RE: 1500 Massachusetts Avenue Arlington Tree Plan

PLAN OF LAND
 IN
 ARLINGTON, MA
 (MIDDLESEX COUNTY)

RE: Article 16 Arlington Tree Bylaw, 1500 Mass Ave

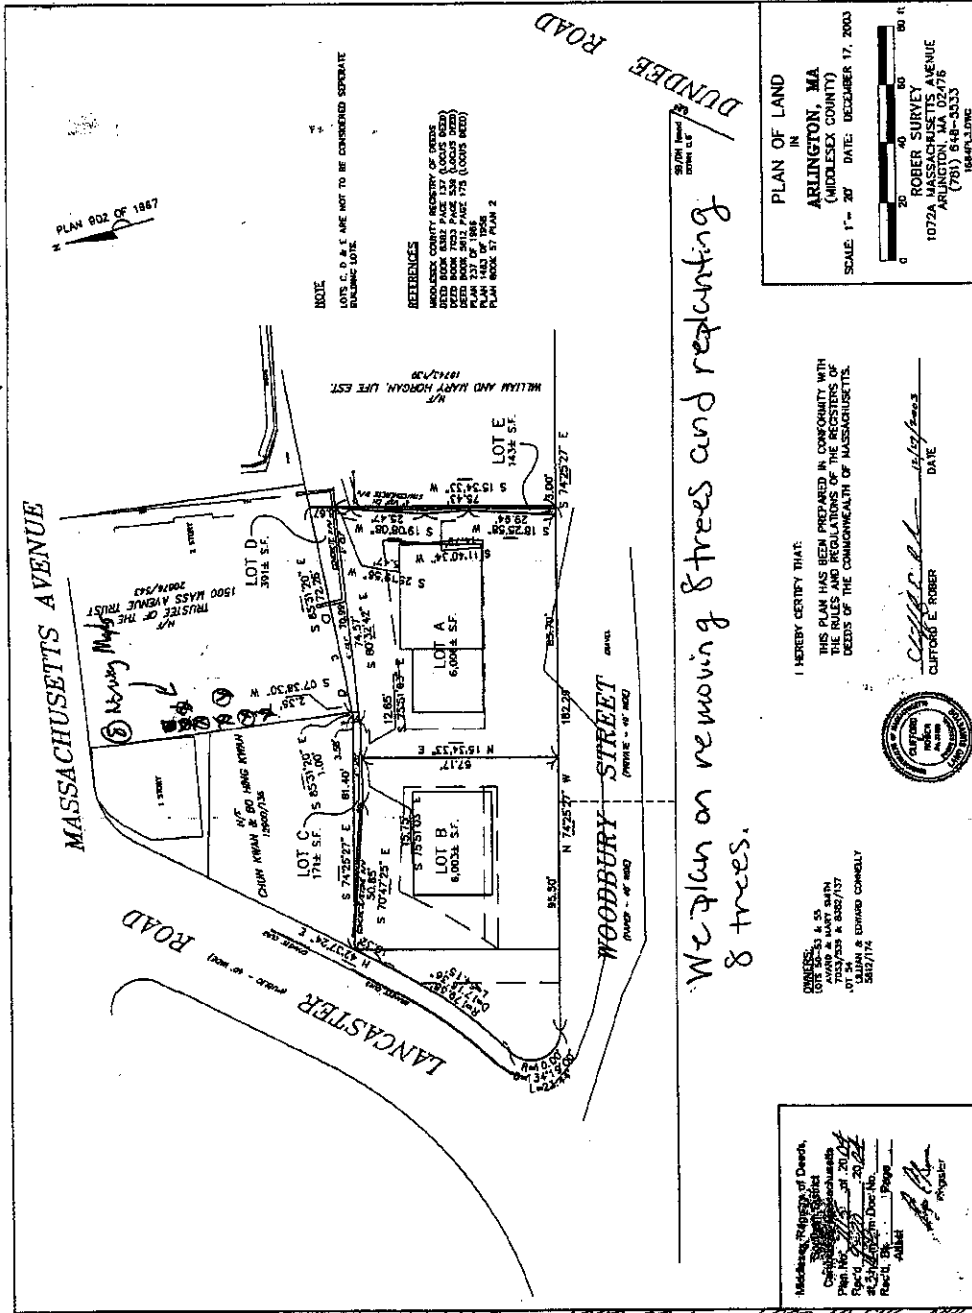
We plan on removing 8 trees and replanting 8 trees.

Thank you for submitting your Tree Plan to comply with, Article 16 "Tree Protection and Preservation." The trees in the 'Setback Area' measuring 10" (DBH) Diameter at Breast Height or larger have identified on your plan. Eight healthy trees have been identified for removal. Eight trees located right side yard.

For each protected tree removed you have agreed to a replacement tree planted on the property no later than 180 days after a Certificate of Occupancy has been issued. The replacement trees planted need to be a minimum caliper of 2.5" and a species native to the area and expected to reach a height 50' or more at maturity.

The Tree Plan you have submitted is consistent with the requirements of the Bylaw, I approve your plan and commencement of work.
